# Property Inspection Report

## OPEN FRAME

[REDACTED]  
[REDACTED]  
**Sierra in West Ranch**

**Monday, December 08, 2014**

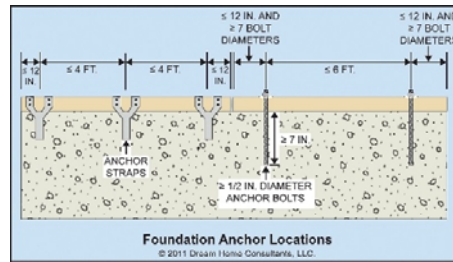
The flashing noted between the side walls and roof was hemmed (also known as "J") or "L" flashing. Flashing against a vertical sidewall should be the step-flashing type or method, a minimum of 4" high and a minimum of 4" wide and turned out at the end of the vertical sidewall in a manner that directs water away from the wall and onto the roof and/or gutter. **NOTE: While this flashing will become acceptable when the 2012 International Residential Code is adopted, and may be accepted by local code authorities, it does not meet the manufacturer's installation requirements.** [IRC 2006 §R905.2.8.4] [IRC 2009 §R905.2.8.3] [IRC 2012 §R905.2.8.3]

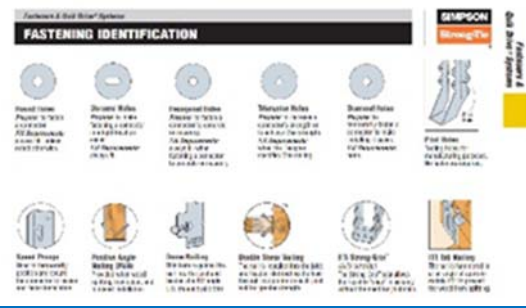
There was no anchor on one of the two sides at each of two splices in the sill plate on the outside wall of the garage. Wood sole plates at all exterior walls on monolithic slabs, wood sole plates of braced wall panels at building interiors on monolithic slabs and all wood sill plates shall be anchored to the foundation with anchor bolts spaced a maximum of 6 feet (1829 mm) on center. [2012 IRC §R403.1.6]

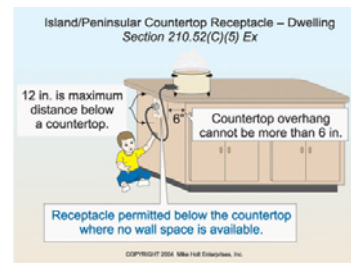
One or more receptacles on the back side of the peninsular counter at the kitchen sink was improperly placed. In kitchens and dining rooms (IRC 2006) or In kitchens, pantries, breakfast rooms, dining rooms and similar areas or dwelling units (IRC 2009 and IRC 2012), an outlet may be located no more than 12 inches below the countertop only when the countertop extends no more than 6" beyond its support base. [2006 IRC §E3801.4 through §E3801.4.5 Exception] [2009 IRC §E3901.4 through §E3901.4.5 Exception] [2012 IRC §E3901.4 through §E3901.4.5 Exception]

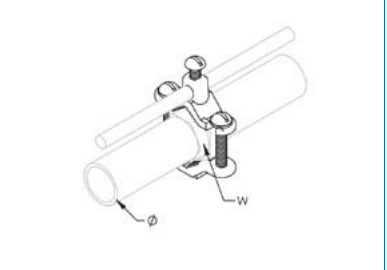
The hydro-massage therapy tub (aka "spa") was not bonded.

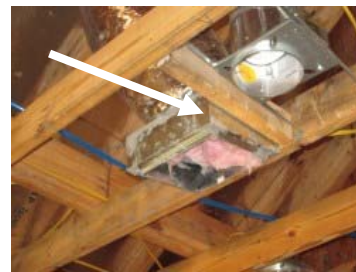
One supply air box above the kitchen space was not rigidly supported or secured to the ceiling framing.
